Re: Preliminary Evaluation of Red Bluff Disposal
of Effluent by Infiltration

As requested by Mr. P.N. Bardal of the Waste Management Branch, a review has been undertaken of the proposal by Urban Systems Ltd., in which a potential sewage effluent infiltration site has been identified in the area northwest of Red Bluff (Figure 1, Disposal Option B1). In connection with this review an appraisal has been made of the groundwater conditions in this area based upon an office analysis of available geologic data, well records and air photographs.

SCALE: VERT. _____	DATE JAN. 1983
HOR. AS SHOWN	APK ENGINEER
FILE No. 93 G1	DWG. No. FIG. 2

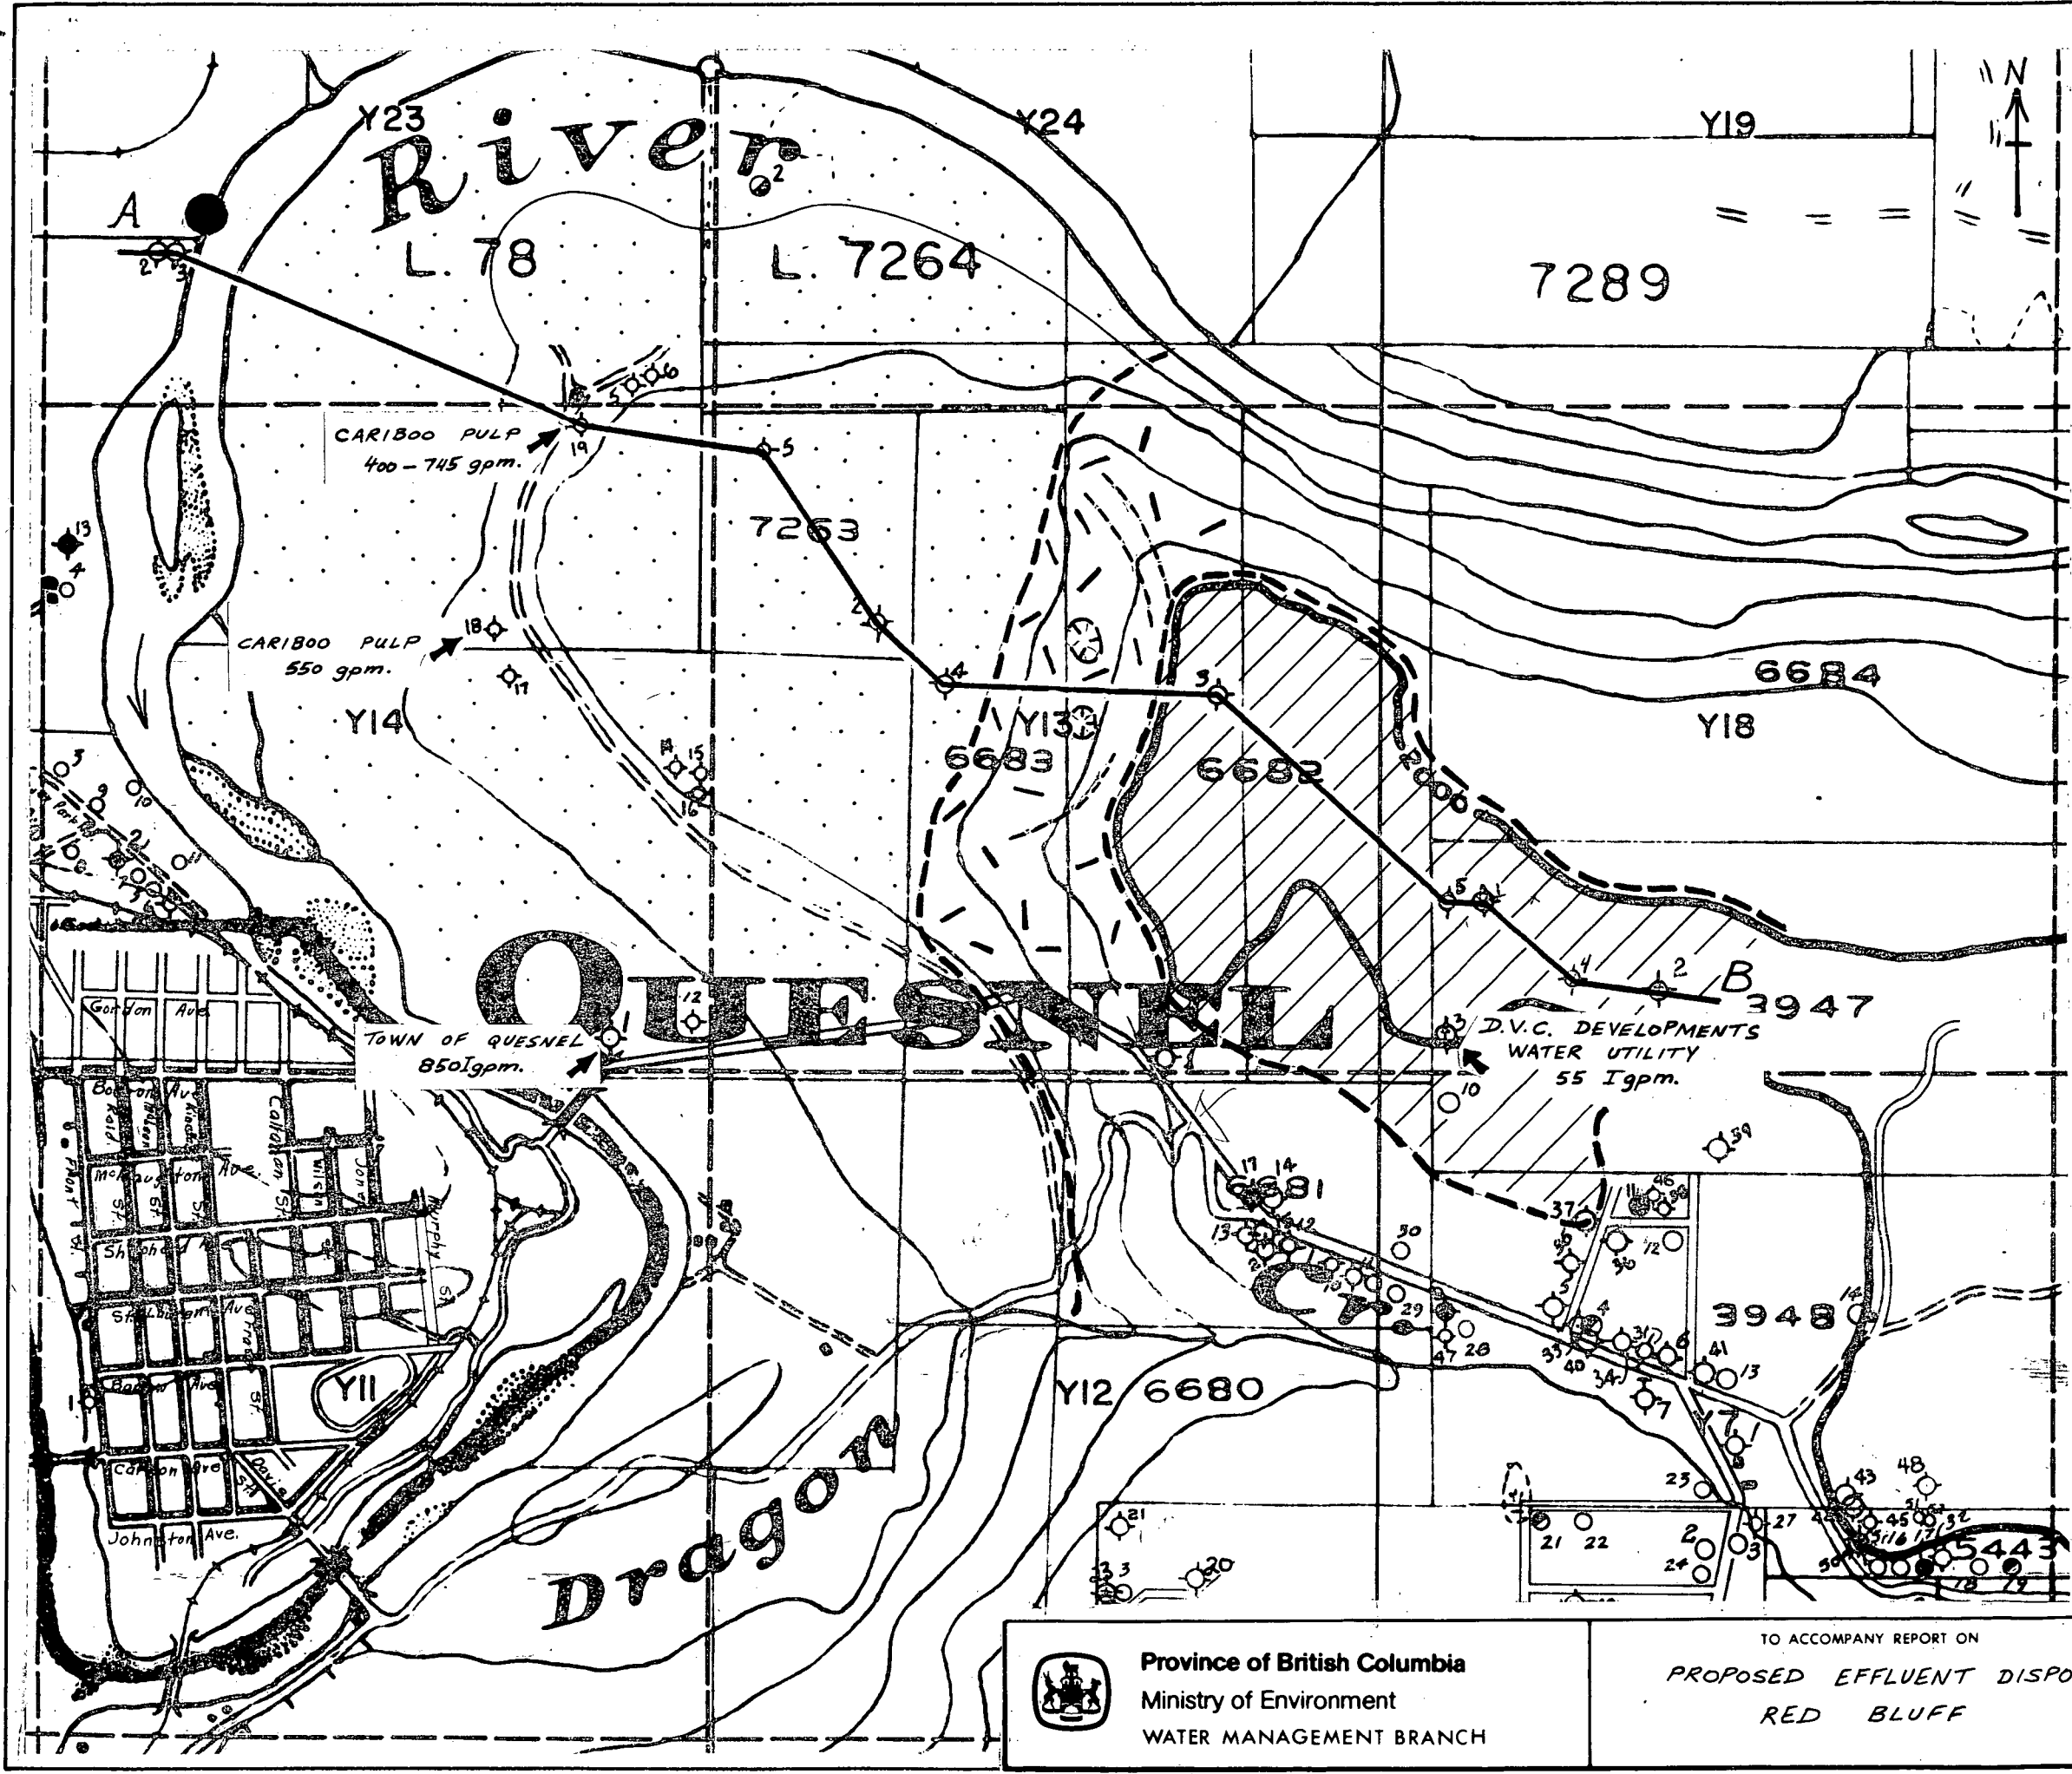
A number of large capacity wells have been completed in the terrace deposits, namely for Cariboo Pulp and Paper and the town of Quesnel. Reported well yields range from 460 to 850 Igpm (34.8 to 64.4 L/s). Present use from these wells is not known. Locations of the high capacity wells are shown on Figure 2. A small number of domestic wells also occur in the area. It is likely that the terrace deposits adjacent to the Quesnel River and the sand and gravel deposits underlying the upland area are in hydraulic continuity comprising a major aquifer underlying the region. Groundwater movement appears to be away from the upland area in a south-westerly direction towards the Quesnel River.

DWG. No. FIG. 3

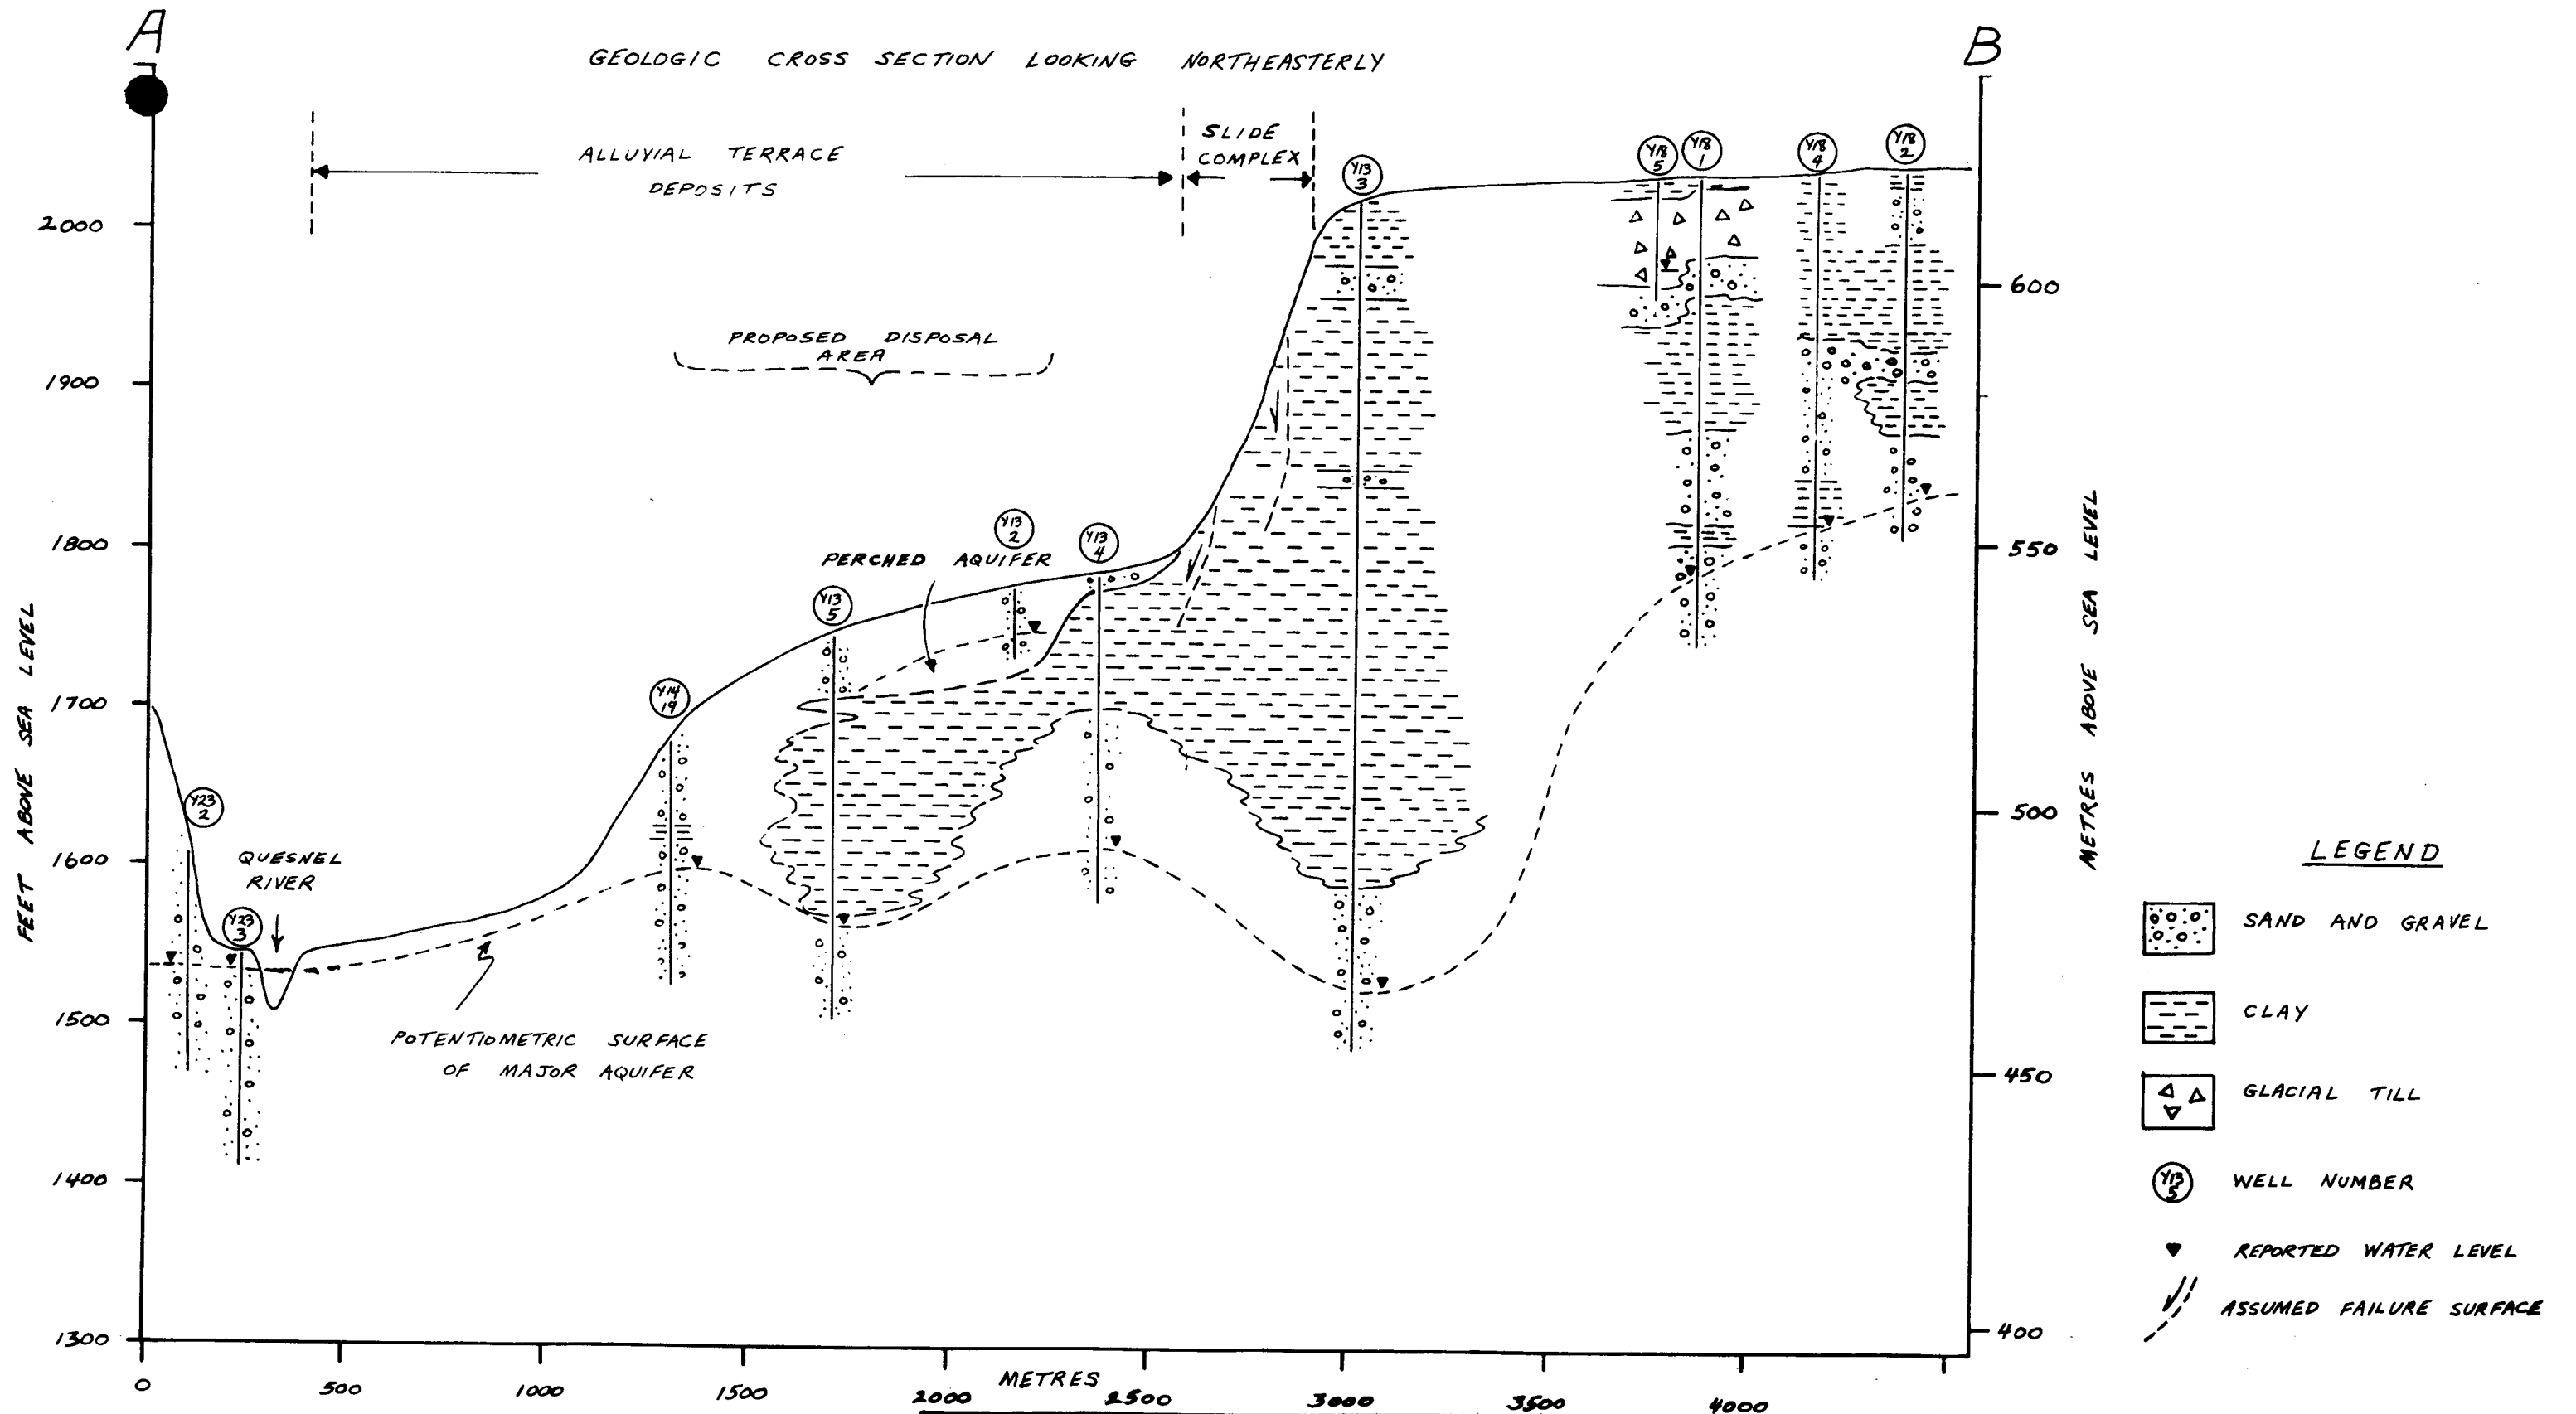
The proposed disposal site is situated on a recent alluvial terrace deposit comprised mainly of sand and gravel (Leaming and Armstrong, 1969). The terrace is one of a series of terraces which occur along the east bank of the Quesnel River near Quesnel. The upper portion of the terrace deposit lies some 200 feet (61 m) above the level of the Quesnel River. Sites where well log information is available in the area are shown in Figure 2. Existing well log data is summarized in Table 1. A geologic cross section looking north through the terrace deposit is shown in Figure 3.

From Figure 3 it appears that the thickness of the sand and gravel terrace deposit ranges in thickness from 15 to 40 feet (4.6 to 12.2 m) thickening westerly towards the Quesnel River where the deposits exceed 100 feet (30 m) in thickness.

The upper portion of the terrace deposit appears to be underlain by clay which may be part of a buried slide deposit. A slide complex occurs along the flanks of the upland east of the terrace deposit and the slide deposits appear to be truncated by the terrace deposits. The upland east of the terrace deposits is underlain mainly by clays, glacial till and sand and gravel at depth. Groundwater occurs at relatively shallow depths approximately 40 feet (12.2 m) below ground where the terrace deposit overlies clay. Further west the water table in the terrace deposit lies some 80 to 90 feet (24.4 to 27.4 m) below ground where the clays are not present. Adjacent to the Quesnel River at lower elevation the groundwater levels are closer to ground
